Three Mile Island Nuclear Station, Unit 1
Renewed Facility Operating License No. DPR-50
NRC Docket No. 50-289

Subject: Second Six-Month Status Report in Response to March 12, 2012 Commission Order Modifying Licenses with Regard to Requirements for Mitigation Strategies for Beyond-Design-Basis External Events (Order Number EA-12-049)

**Second Six-Month Status Report for the Implementation of Order EA-12-049, Order
Modifying Licenses with Regard to Requirements for Mitigation Strategies for Beyond-
Design-Basis External Events**

1E-919-21-001, draft, FLEX Diesel Generator and Fuel Oil System

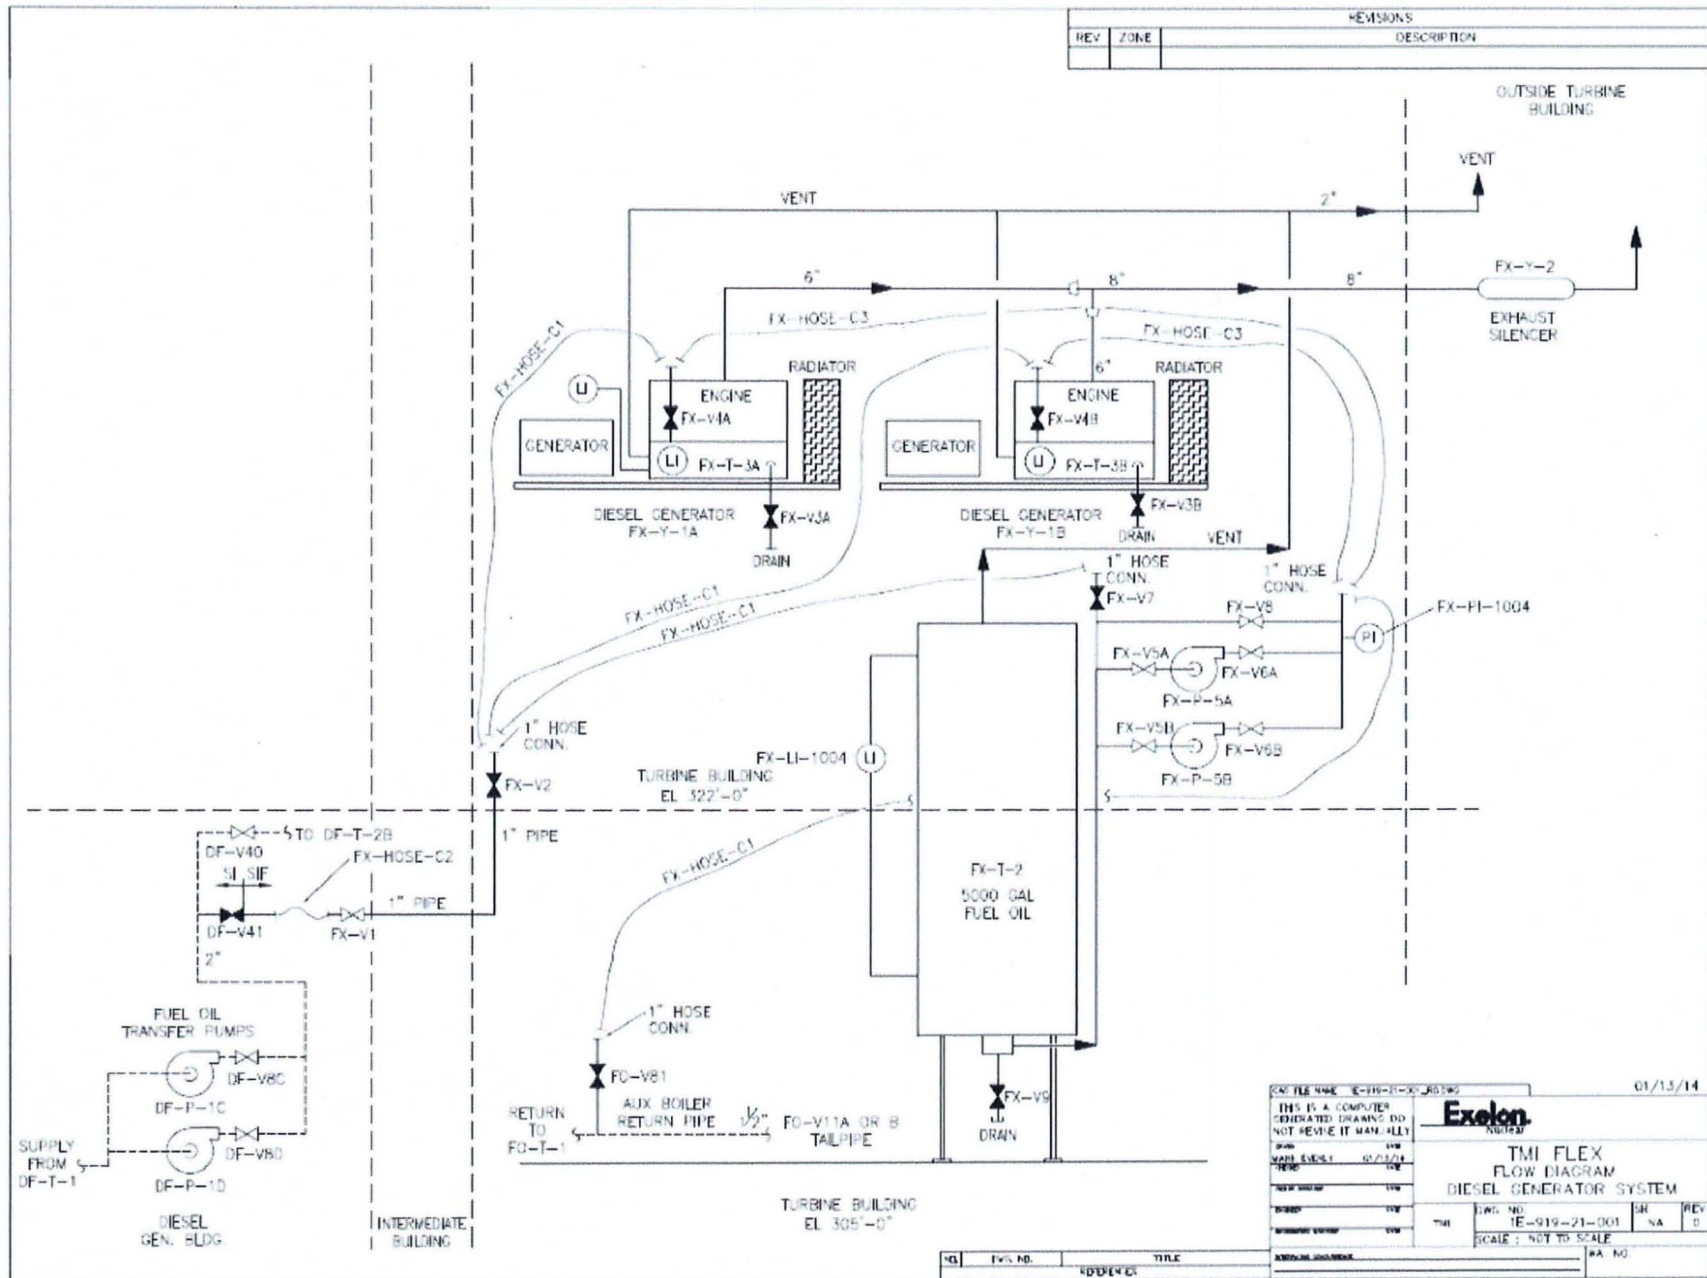
- (1) FLEX Diesel Generator and Fuel Oil Supply (Reference Attachment 2A)
 - FLEX Diesel Generators FX-Y-1A & B and FX-T-2 will be located at the south end of the Turbine Bldg

- Skid mounted fuel tanks will be used for the initial supply. FX-T-2 will normally be empty and only used for floods. Fuel Supply from DF-T-1 will directly fill FX-T-2, or FX-Y-1A or B skid mounted tanks. New pumps (FX-P-5A & B) will be used to transfer fuel from FX-T-2 to the skid mounted fuel tanks.

1E-919-21-002, draft, FLEX Electrical Distribution

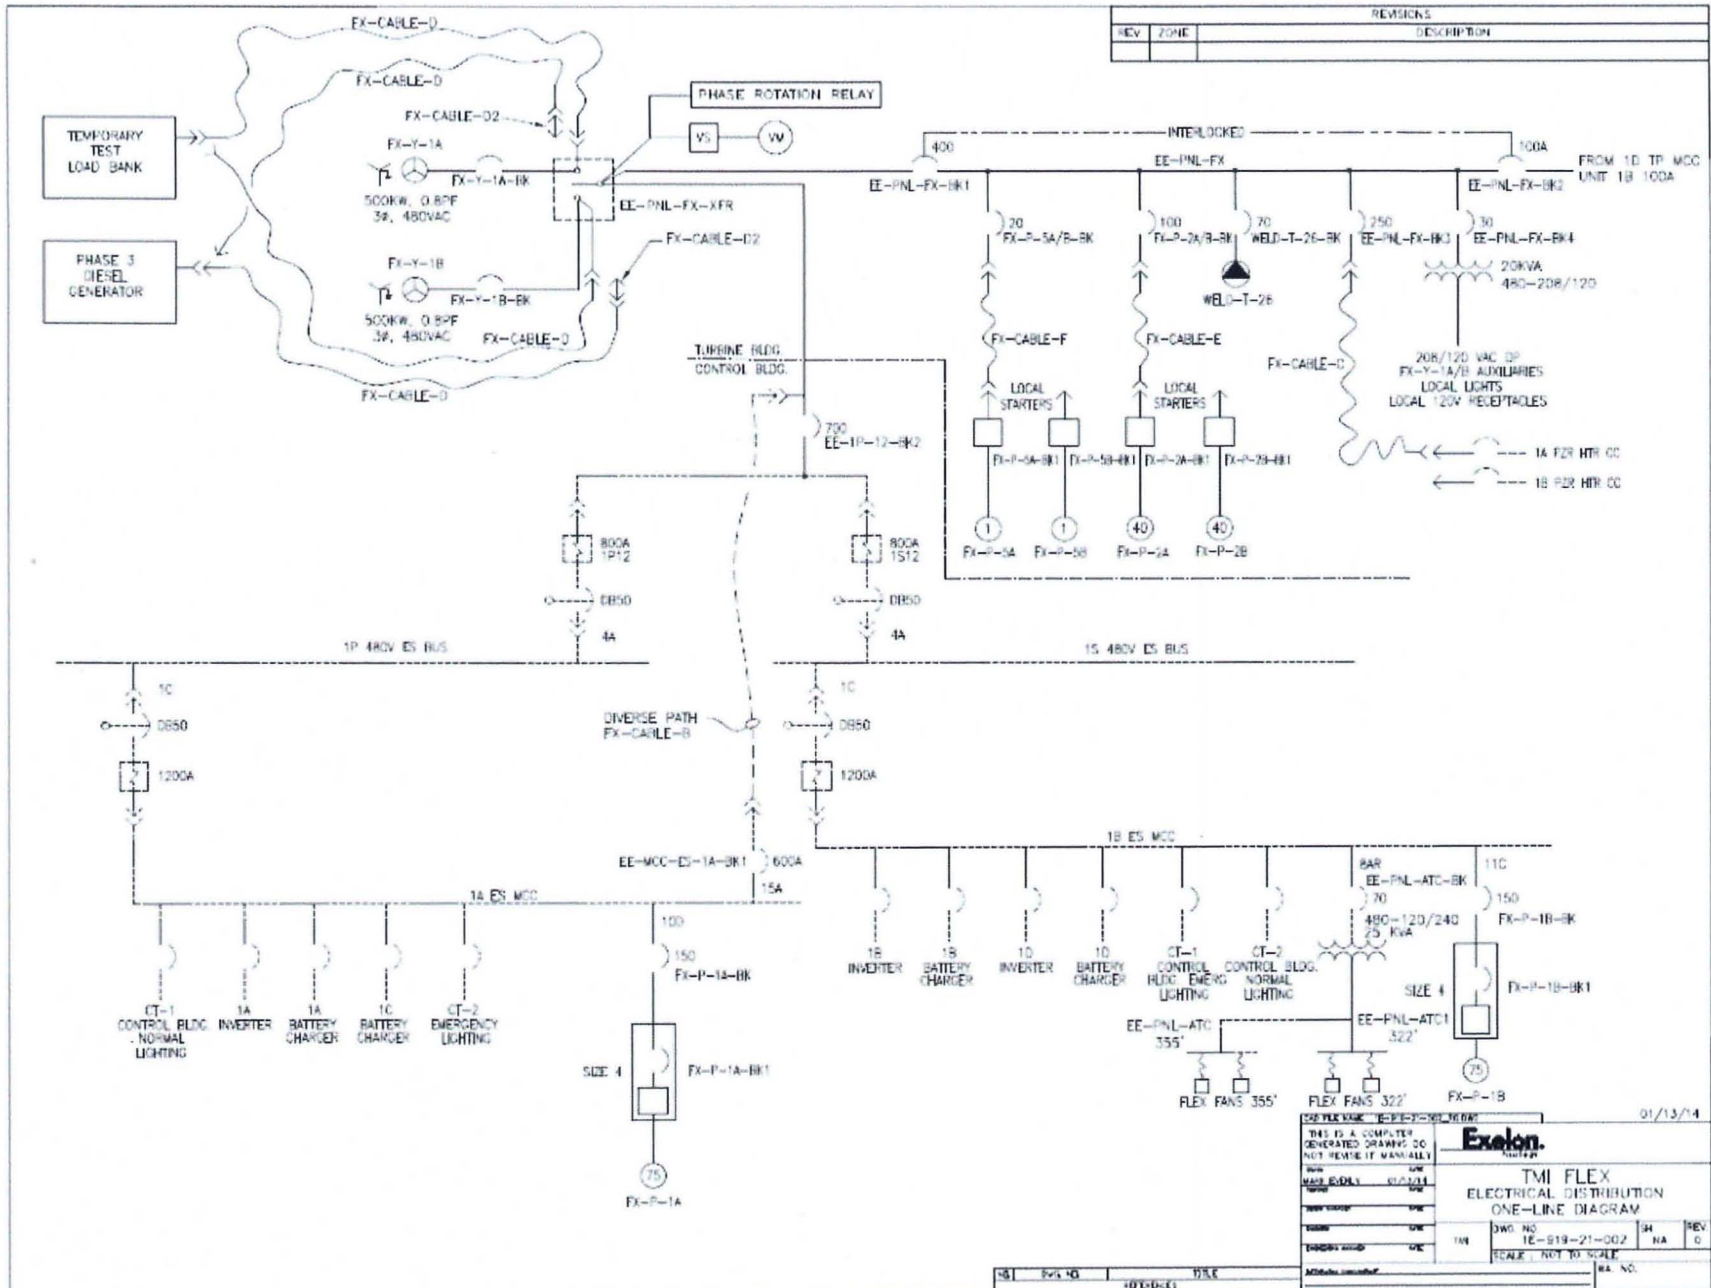
- (2) FLEX Electrical Distribution (Reference Attachment 2B)
 - A 480V distribution panel and a transfer switch replace the FLEX 480V MCC
 - Temporary cable will be used for power to FX-P-2A & B

- The temporary power feed to RB H&V MCC is no longer required
 - 120VAC regulated panel ATC will be modified to provide power to FLEX temporary ventilation

Attachment 2C 1E-919-21-003, draft, FLEX Feedwater System

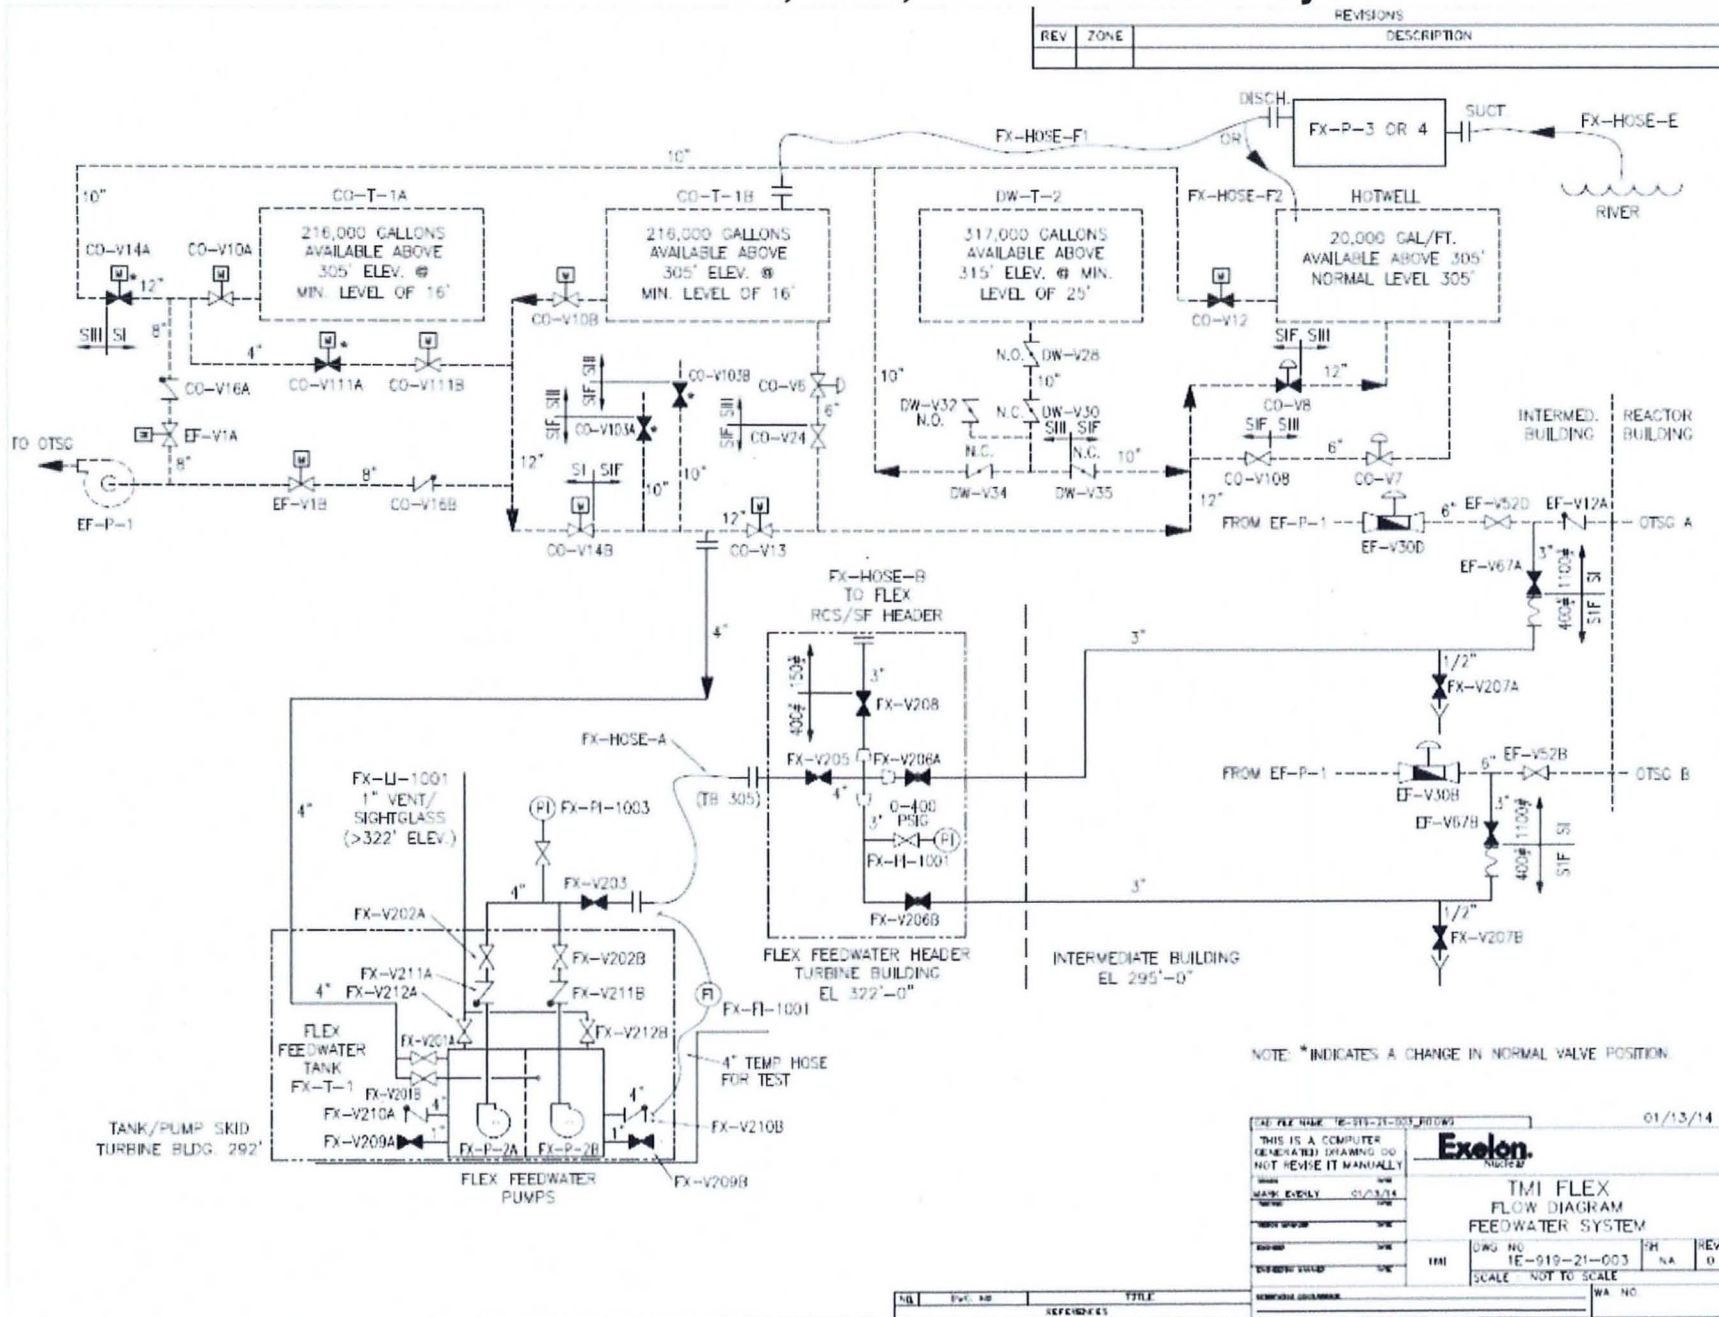
- (3) FLEX Feedwater System (Reference Attachment 2C)
 - Capacity of FX-P-2A & B was increased, and series operation with a portable diesel driven pump (FX-P-3 or 4) was eliminated.

1E-919-21-004, draft, FLEX RCS and SFP Makeup System

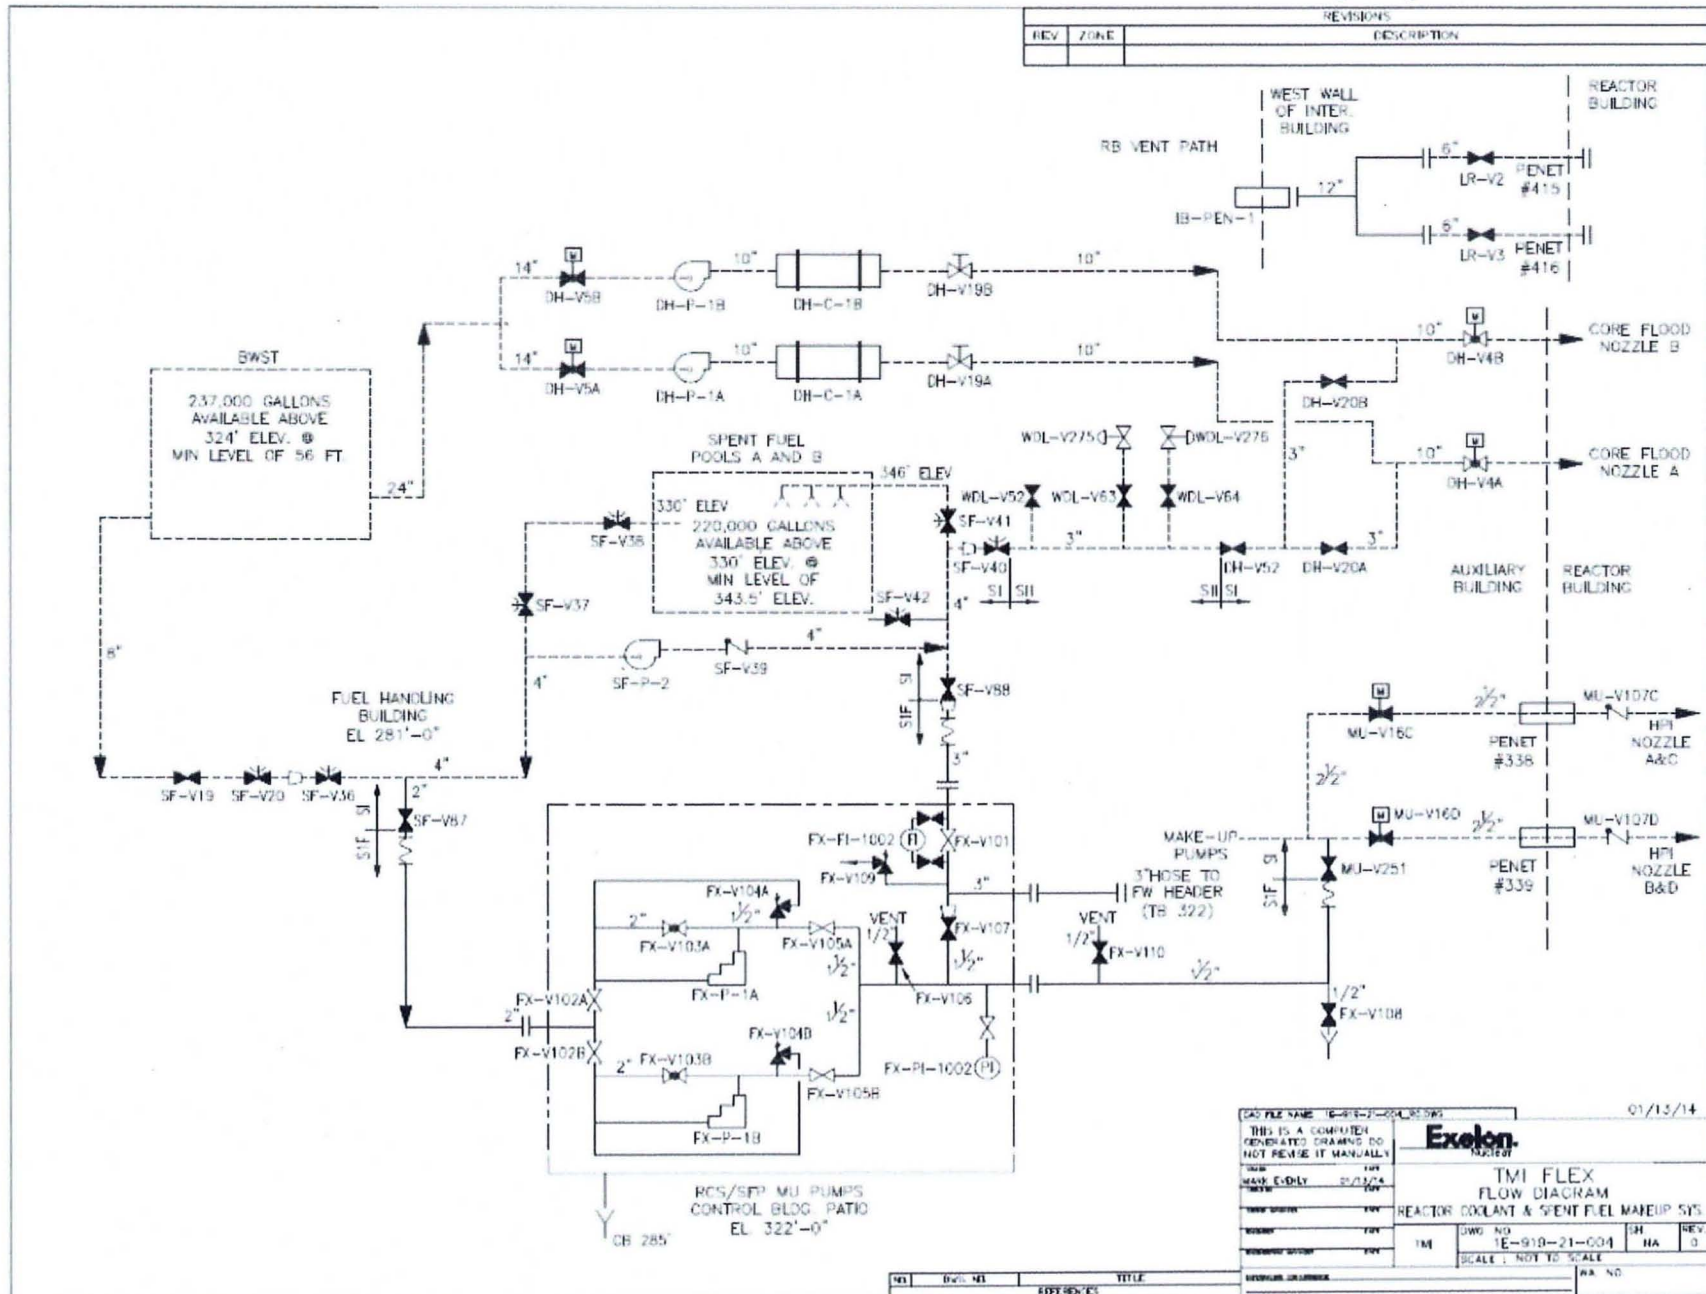
- (4) FLEX RCS and SFP Makeup System (Reference Attachment 2D)
 - Added flow path for core cooling via Spent Fuel Pool gravity drain
 - Added RB vent path
